SUBJECT: ISSUANCE OF AMENDMENT NO. 56 TO FACILITY OPERATING LICENSE  
NO. NPF-29 - GRAND GULF NUCLEAR STATION, UNIT 1, REGARDING  
SNUBBER SURVEILLANCE TESTING (TAC NO. 68980)

AMENDMENT NO. 56 TO FACILITY OPERATING LICENSE NO. NPF-29 - GRAND GULF

SAFETY EVALUATION BY THE OFFICE OF NUCLEAR REACTOR REGULATION

SUPPORTING AMENDMENT NO. 56 TO FACILITY OPERATING LICENSE NO. NPF-29

FIGURE 4.7.4-1  
 (SAMPLE PLAN 2) FOR SNUBBER FUNCTIONAL TEST

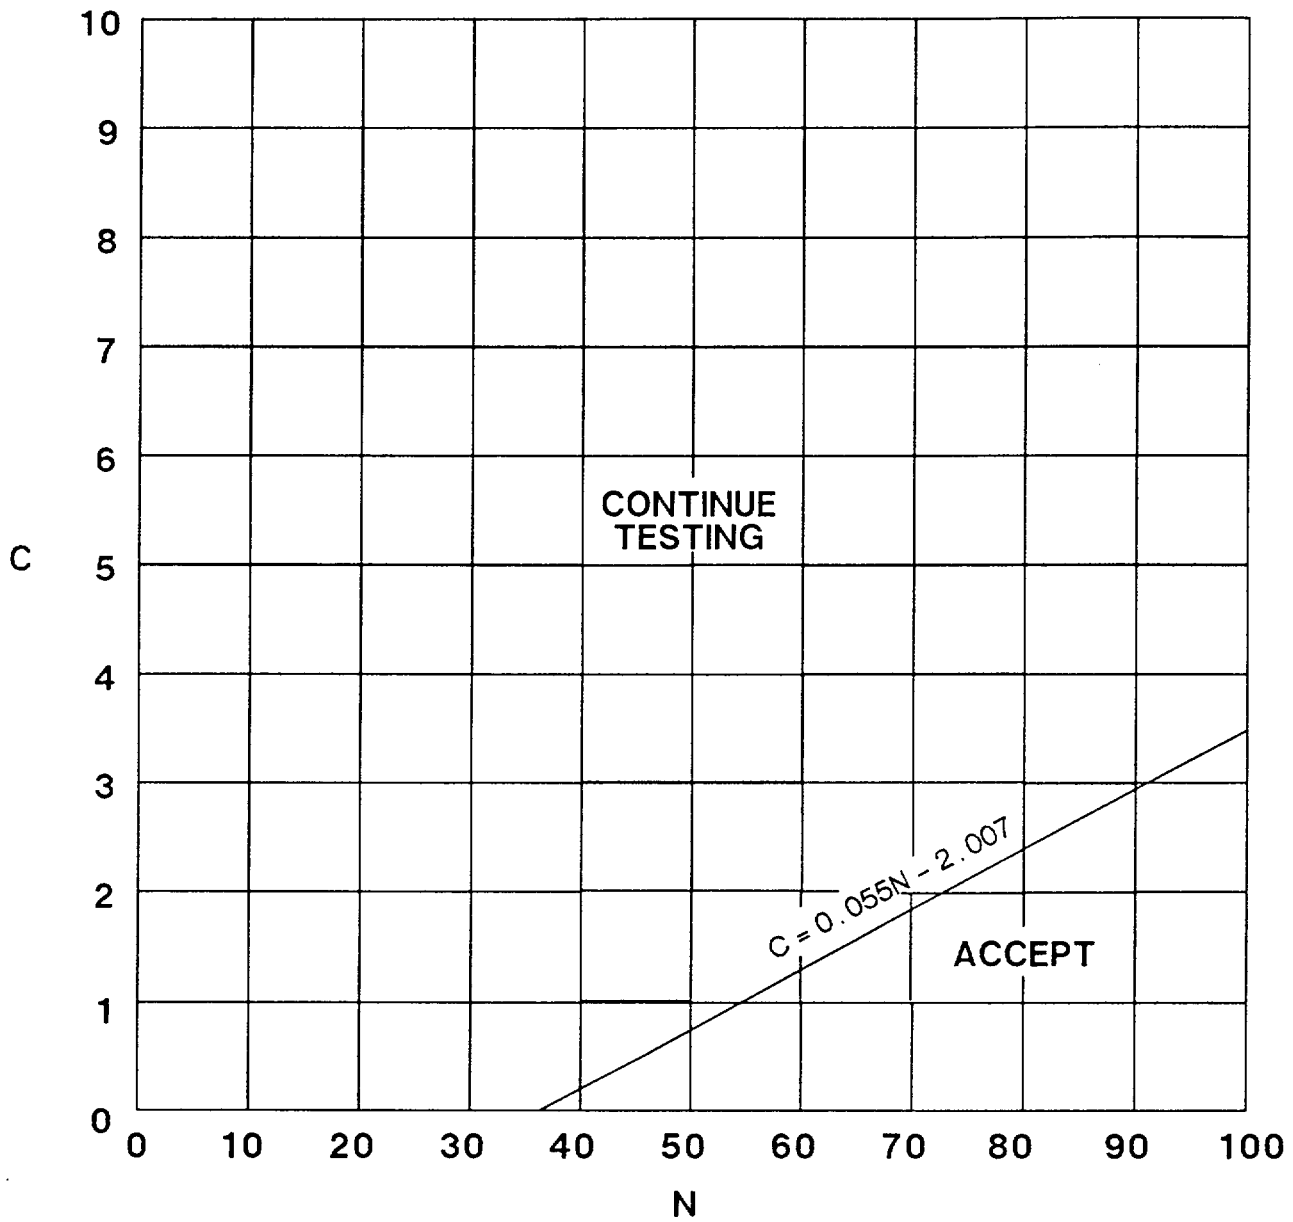
The amendment changes TS 3/4.7.4, "Snubbers," and the associated Bases by:  
(1) changing sampling plan No. 2 to eliminate the requirement to test all snubbers if the number of rejected snubbers exceeds a specified number, and  
(2) deleting sampling plan No. 3.

For Plan No. 2, test results for a given snubber type are plotted on TS Figure 4.7.4-1, where N is the number of snubbers tested and C is the number of test failures. The plot of test results falls into one of three regions: (1) the "accept" region which indicates that snubber type can be terminated; (2) the "continue testing" region which indicates that testing of that snubber type must continue, or (3) the "reject" region which indicates that all snubbers of that type are required to be tested. The "reject" region

of TS Figure 4.7.4-1 provides the possibility of rejecting a good population of snubbers and requiring functional testing of the entire snubber population. Functional testing of the entire population requires increased radiological exposure of test personnel.

The first change in the licensee's proposal is based on an analysis of Wald's sequential sampling plan. An evaluation of the Wald's sequential sampling plan formulas for acceptance and rejection numbers shows that reducing the probability of accepting a good population to zero, while holding constant the probability of accepting a bad population, has the effect of eliminating the "reject" region without significantly changing the accept region. Therefore, acceptance is essentially independent of rejection. The proposed change to eliminate the "reject" region maintains the currently approved acceptance criteria, while eliminating the potential for excessive snubber testing. These results were developed by the American National Standards Institute/American Society of Mechanical Engineers Code Committee (ANSI/ASME OM4 Committee) which develops standards for testing snubbers.

Although, the acceptance criteria in the Wald's sequential sampling plan are essentially independent of the rejection criteria, a slight dependence exists. The elimination of the rejection criteria without a corresponding change to the acceptance criteria will result in a very small increase in the probability of accepting a bad population. For the change being proposed, SERI has determined this negligible increase in probability to be less than 0.003. This determination was made by setting the probability of rejecting a good population to zero and then calculating the change in the probability of accepting a bad population required to duplicate the "accept" region of TS Figure 4.7.4-1.

- 2) A representative sample of each type of snubber shall be functionally tested in accordance with Figure 4.7.4-1. "C" is the total number of snubbers of a type found not meeting the acceptance requirements of Specification 4.7.4.f. The cumulative number of snubbers of a type tested is denoted by "N". At the end of each day's testing, the new values of "N" and "C" (previous day's total plus current day's increments) shall be plotted on Figure 4.7.4-1. If at any time the point plotted falls in the "Accept" region, testing of snubbers of that type may be terminated. When the point plotted lies in the "Continue Testing" region, additional snubbers of that type shall be tested until the point falls in the "Accept" region or all the snubbers of that type have been tested.

On the basis of this evaluation, we conclude that the proposed changes to the TS are acceptable because the acceptance criteria for surveillance testing of snubbers remain essentially unchanged. Also, the proposed changes do not significantly reduce the previous confidence level of snubber population acceptance and have no significant effect on the structural integrity of safety-related systems or margins of safety. In addition, radiological exposure to test personnel would be reduced with little, if any, increase in the probability of accepting a bad population of snubbers.
